February 13, 2009

Applies To: **2009 Odyssey** – From VIN 5FNRL3...9B043589 thru 5FNRL3...9B045212

Safety Recall: Brake Hoses Rub On the Front Caliper Upper Pin Bolts

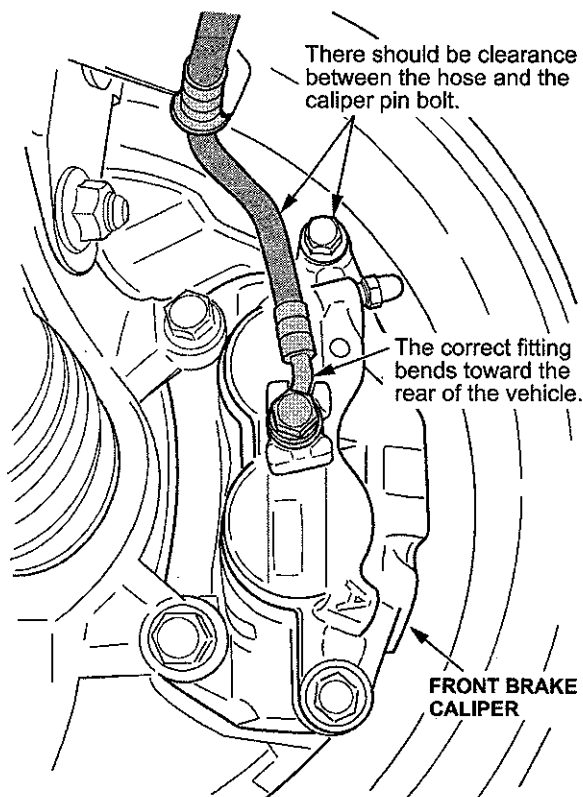
- Good hoses have a bend in the tubing at the caliper end, along with clearance between the hose and the caliper upper pin bolt. If both hoses are OK, go to step 2.
- Incorrect hoses have straight tubing at the caliper end, and little or no clearance between the hose and the caliper upper pin bolt. If either hose is incorrect, go to REPAIR PROCEDURE.

CORRECT

INCORRECT

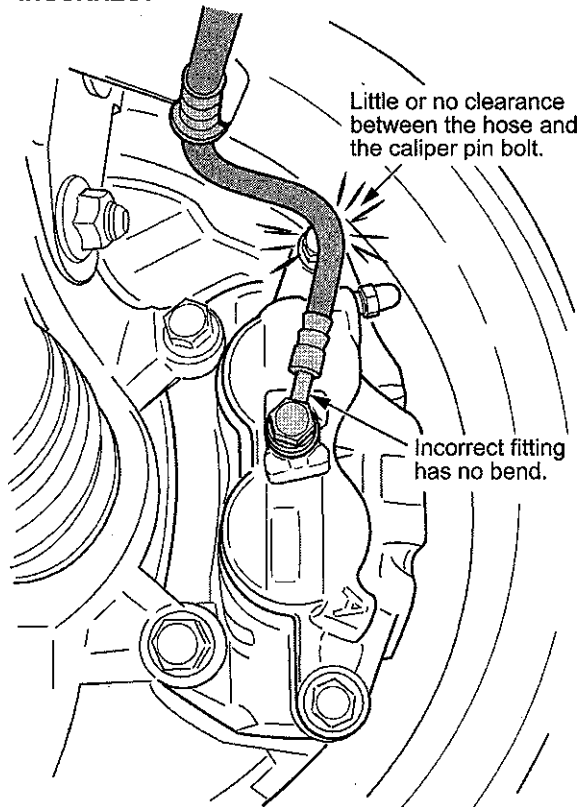
2. Center-punch a completion mark above the first character of the engine compartment VIN:

Center-punch here.
